SERVICE LETTER 33

CONVERSION OF MODEL 6000 TO MODEL 6100 FLOAT

Aircraft Makes/Model(s):	Float Model(s):	Compliance: Recommended	By: MAS
DHC-2 MK III	6000	Part Number: 1002411	Approved: SDW
		Date: 5/18/2022	Revision: E

TECHNICAL DATA:

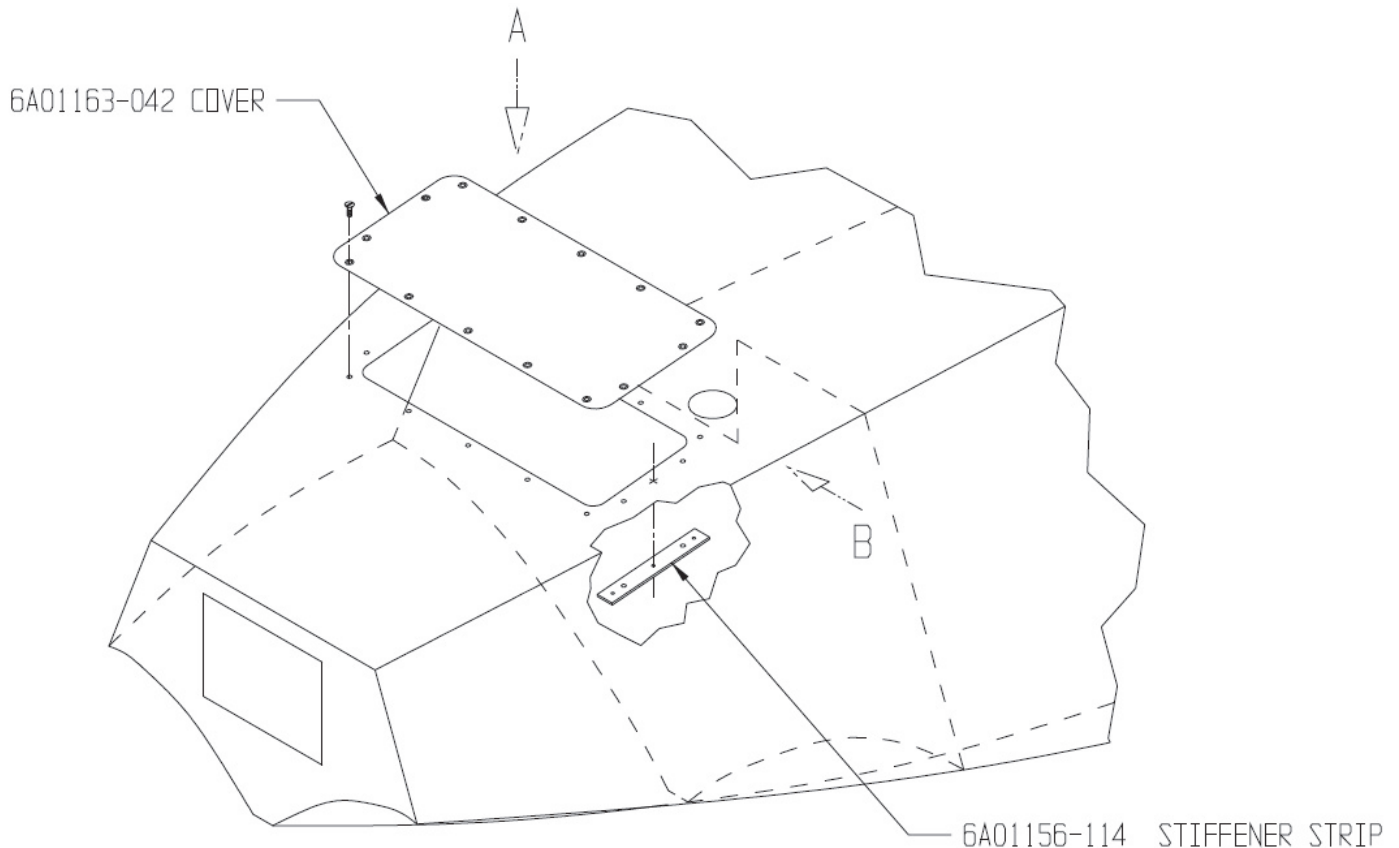
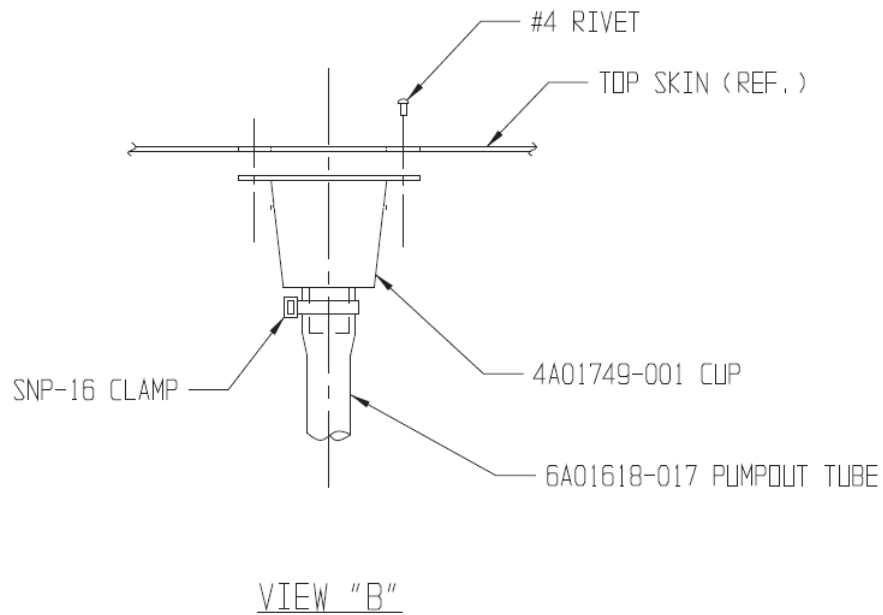
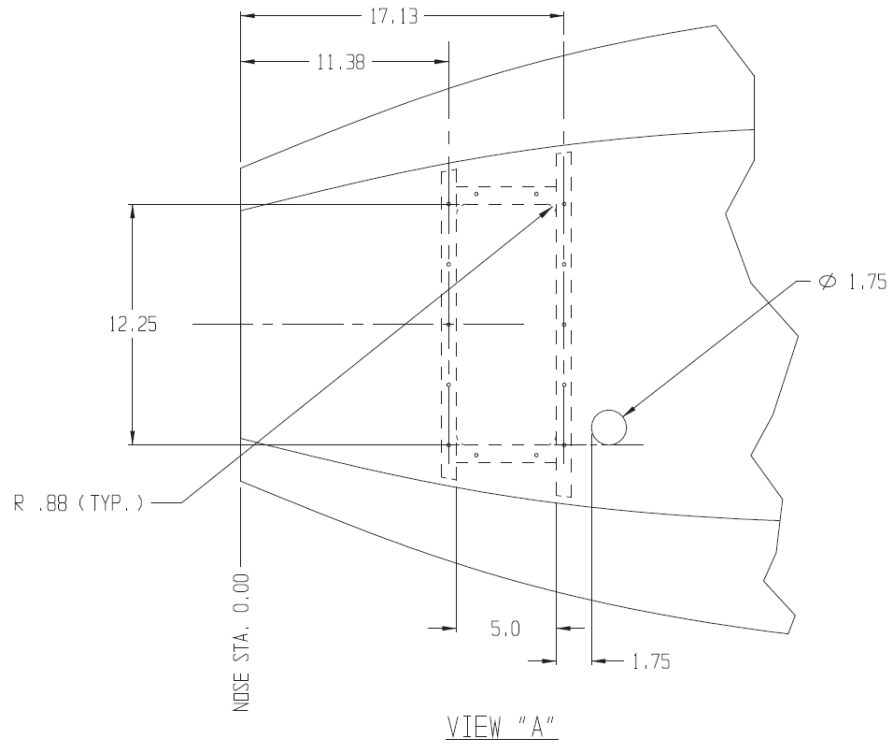
1. Drill out all rivets in top skin angles approximately 11.375 and 17.125 aft face of nose bulkhead.
2. Center template on top skin centerline.
3. Layout 5" X 12.25" hole on top skin and cut out between stiffeners.

4. Match drill #10 holes from template thru top skin and top skin angles for cover attach holes, #30 holes for nutplate attach.
5. Countersink all remaining holes in top skin and install AN426AD4 rivets.

6. Install 6A01156-114 strip under skin before installing 9A3-671 nutplates.
7. Locate 1.75 pump-out cup hole from template and install 3A01650-002 cup, 3A01650-002 ring. Rivet to topskin.

8. Install 3A01158-003 clamp on FWD side of #3 bulkhead, approximately 3" up from keel.
9. Install pump-out tube (20.5"). Secure top of tube to pump-out cup with SNP-16 clamp.

10. Install 9A3-671 nutplates and insulators to inside of top skin angles with AN426AD4 rivets.
11. Seal completely around #3 bulkhead. Water check after sealing.

12. If amphibious float, seal around nose box at #3 bulkhead. If seaplane float, install 6P01158-157 cover over nose box hole in #3 bulkhead. Match drill and secure with AN470AD4 rivets.

13. Apply caulking around cut-out and attach 6A01163-042 cover with #8 X 3/4" screws.
14. Amphibian floats, rework existing model 6000 shock struts with parts provided in kit while referencing current 6100 IPC and Service Manual.
